# CITY OF ALBUQUERQUE

**RE: 12100 Copper  
Grading and Drainage Plan  
Engineer's Stamp Date: 6/15/2022  
Hydrology File: K22D064**

Based upon the information provided in your submittal received 6/15/2022, the Grading & Drainage Plan is **not** approved for Grading or Building Permit. The following comments need to be addressed for approval of the above referenced project:

ENGINEER'S SEAL  6/15/22	12100 COPPER TOWNHOMES GRADING AND DRAINAGE PLAN	DRAWN BY WCWJ DATE 6-14-22 20220047-LAYOUT-6-14-22
	 1606 CENTRAL AVENUE SUITE 201 ALBUQUERQUE, NM 87106 (505) 872-0999	SHEET # — JOB # 20220047

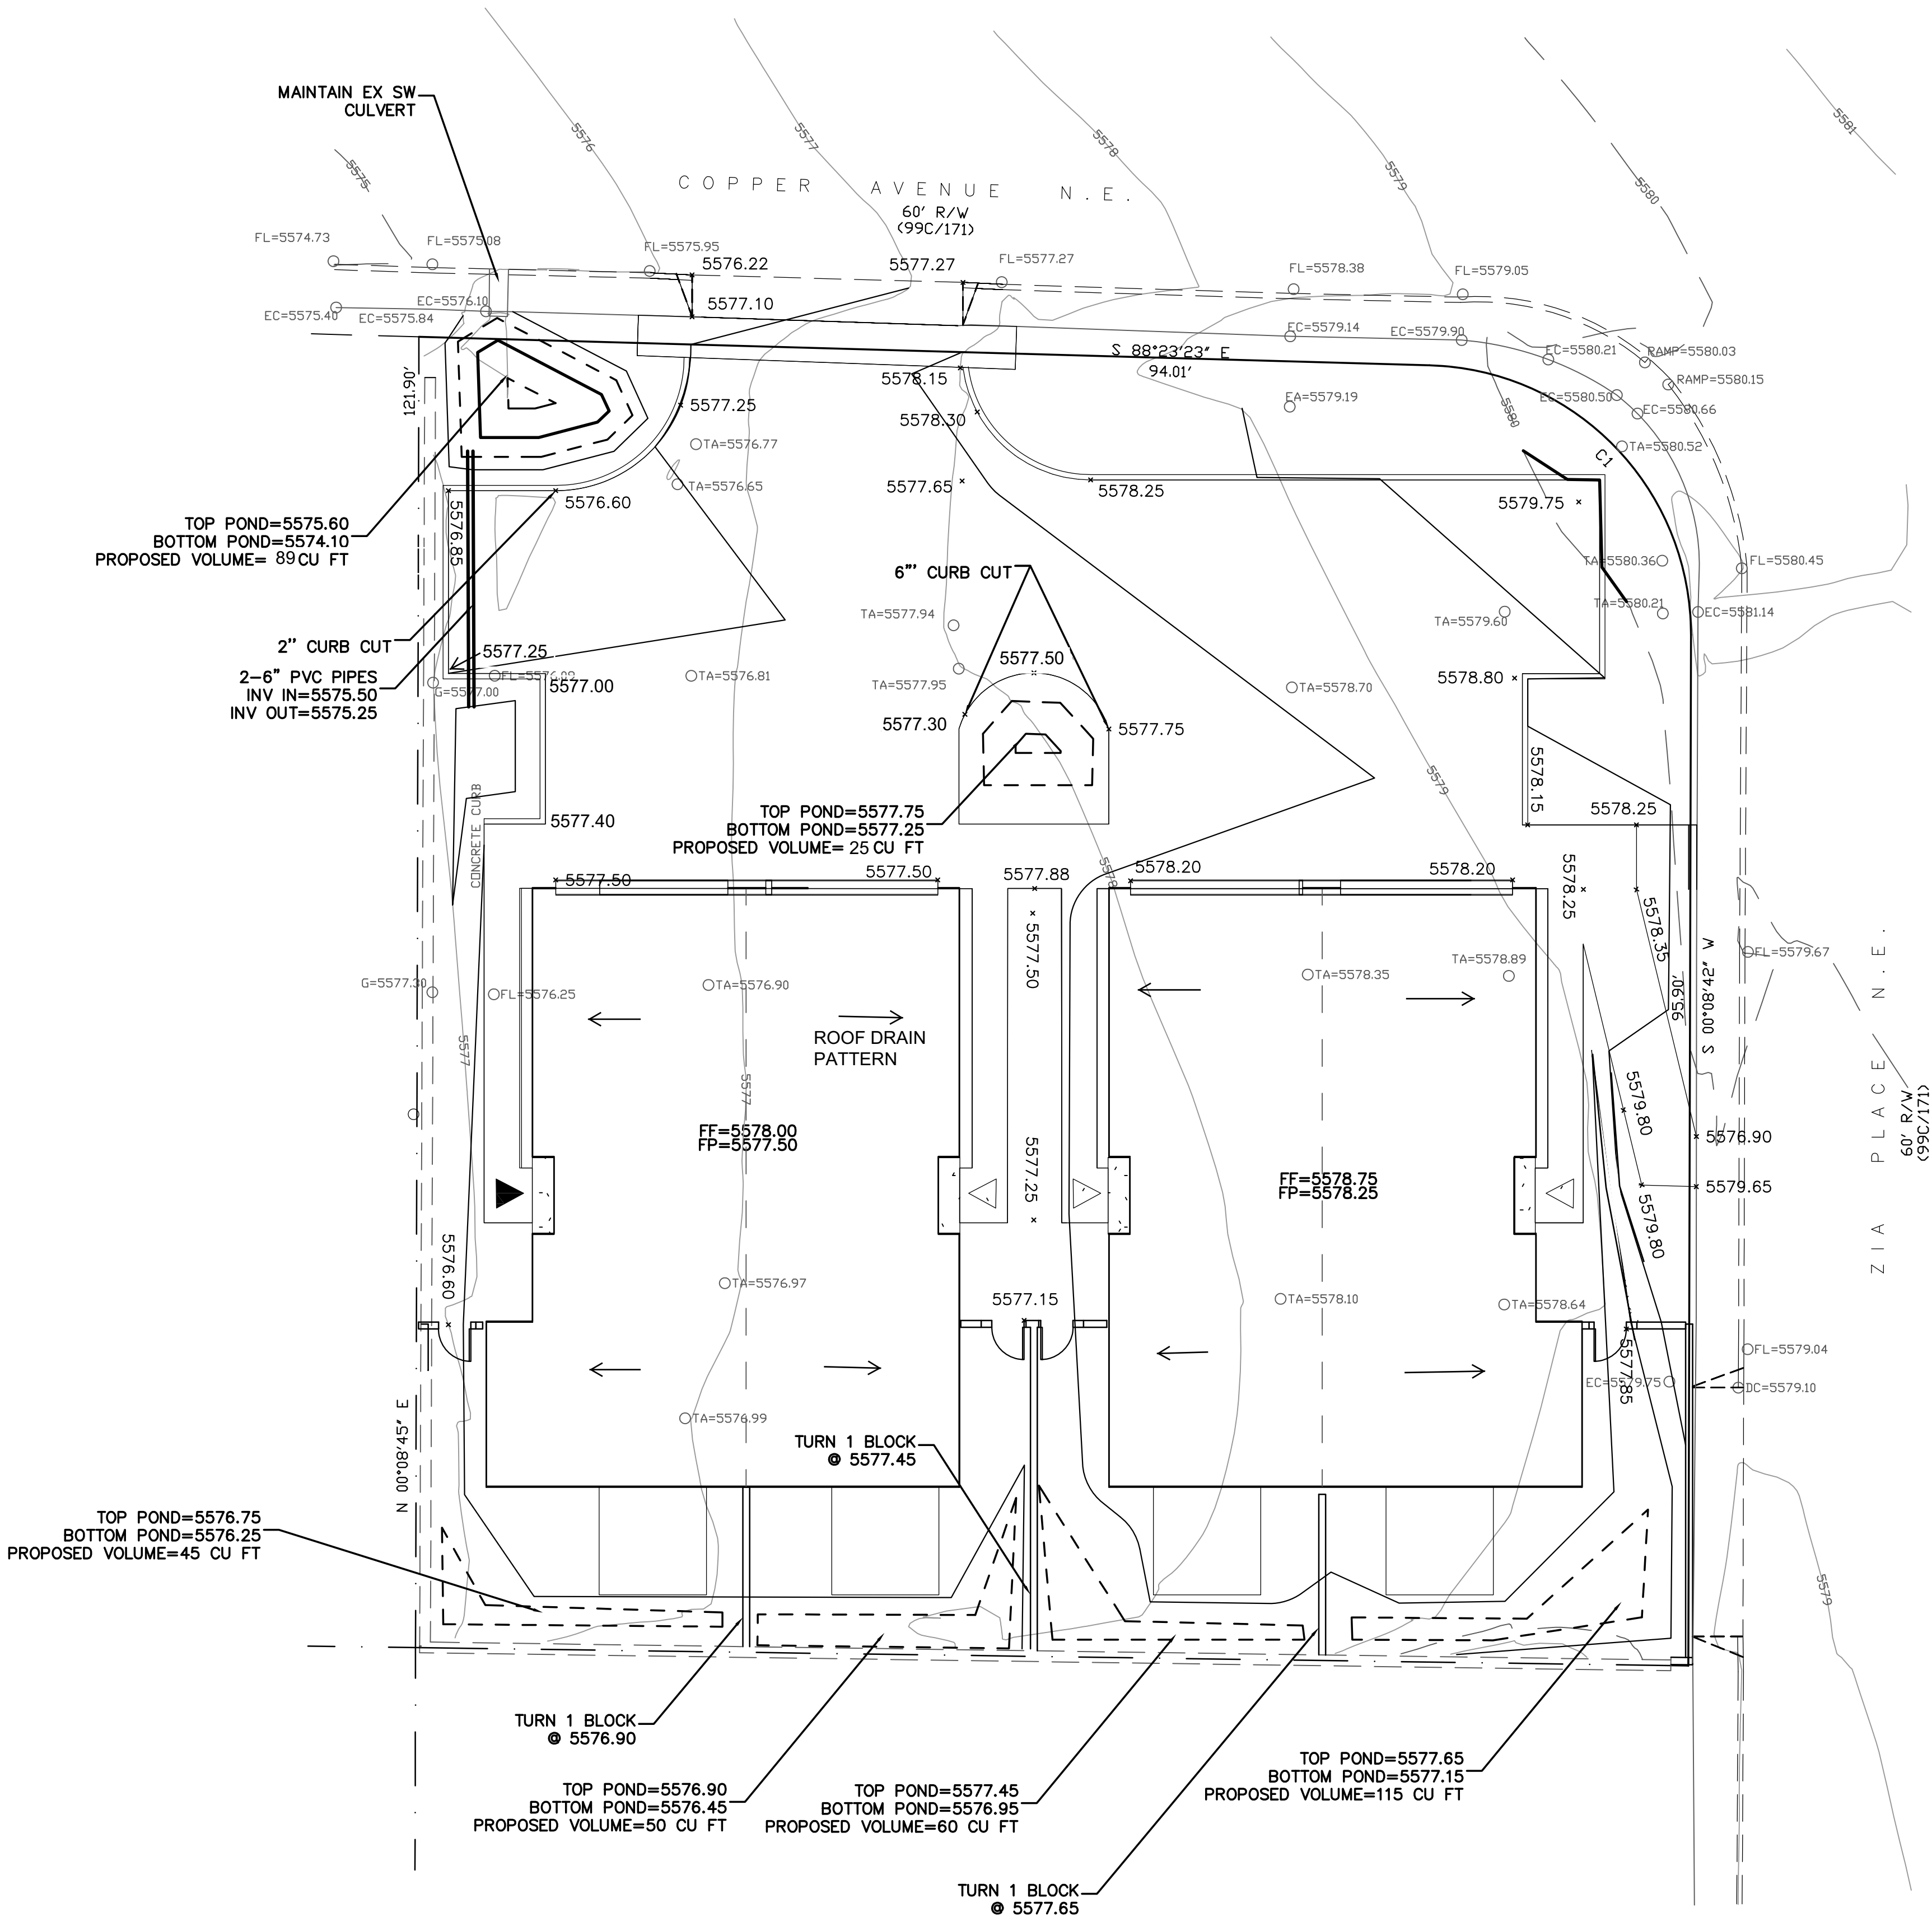
1. Please provide pond sections with elevations for:
  - a. Bottom, top, outlet, and SWQV. Back pond/front pond.
  - b. Are these stormwater quality ponds? Detention?
  - c. Please label ponds.
2. Please make the small text large enough to read at scale.
3. Please include benchmark and datum.
4. Is there an existing wall? If so call it out with BW/TW elevations.
- 5.
